ContiPressureCheck™

Introduction of New Features in Handheld Tool Software
Version 6.00 compared to 5.02

26. January 2015

Reception Issues

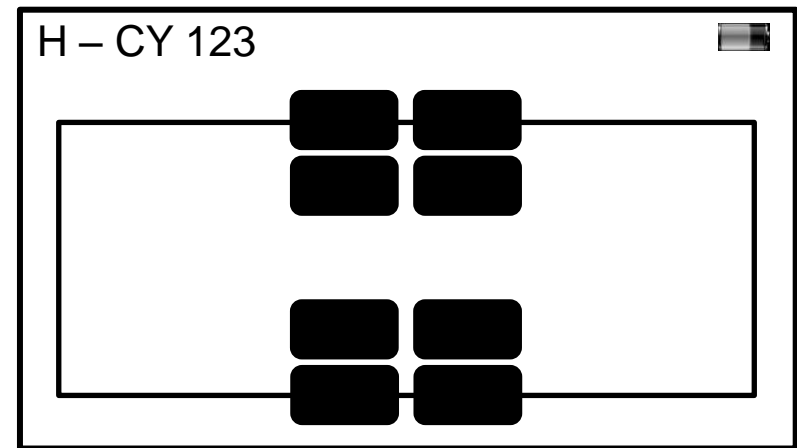
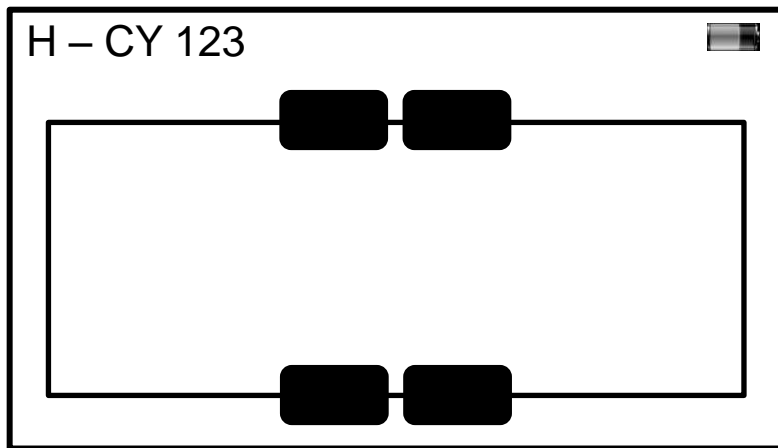
- › Due to software issues, sometimes there was no reception on some handheld tools. This might happen even if the handheld tool and sensor were close to each other on the desk.

- › **With SW 6.00 this issue is solved.**
- › Nevertheless, for some HHT the following case can rarely happen (see also FAQs: http://www.continental-truck-tires.com/www/transport_de_en/themes/contipressurecheck_ov_channel/faq/09_best_practice/):

- › *The tire sensor on the inner dual tire section is not found during the fetching process. What can I do?*
 - › *In rare cases, the tire sensor may not be detected if it is simultaneously in the inner dual tire section and in the tire ground contact area. Please move the vehicle forward or backward by half of one tire circumference, then repeat the fetching process.*

- › *If this inner section can be accessed directly, continue the fetching process by guiding the handheld tool directly along this dual tire.*

Case: Sensor acquisition interrupted when 2 sensors were fetched.

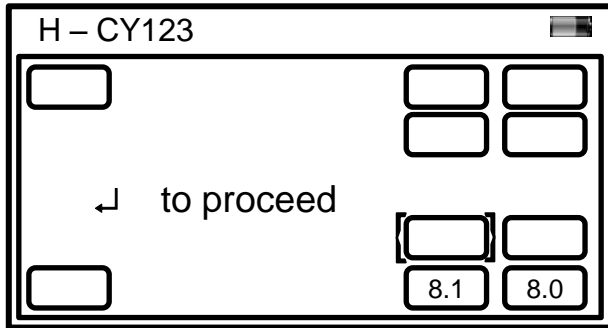
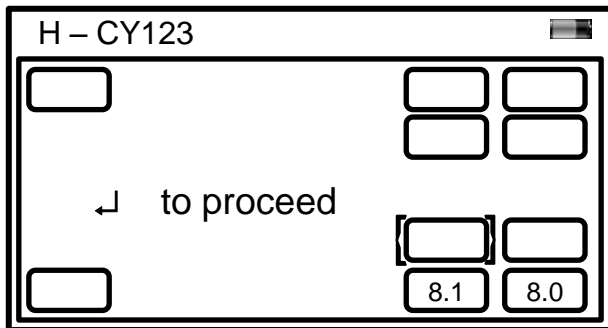
SW 5.02

SW 6.00

- Exit “New Installation” by pressing ESC for 3 sec.
- Enter “Resume Installation” to continue TEACH-IN.

“Resume Installation”:

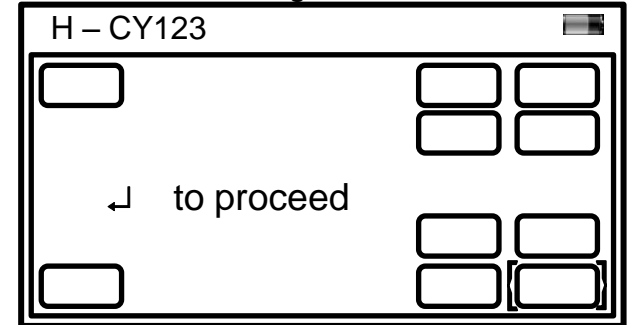
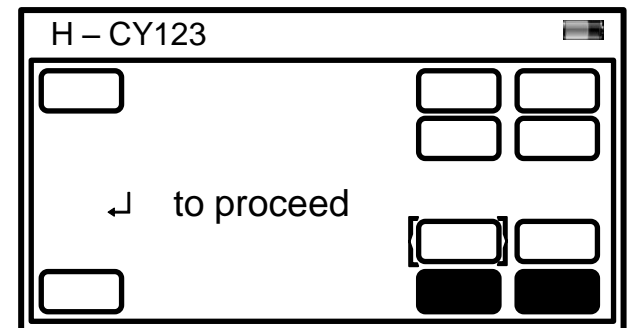
SW 5.02: Starts again with first tire.

SW 6.00: Continues with third tire.

IDs of first 2 sensor are stored in HHT memory. Pressure values can't be shown, therefore the tire boxes are set to black.
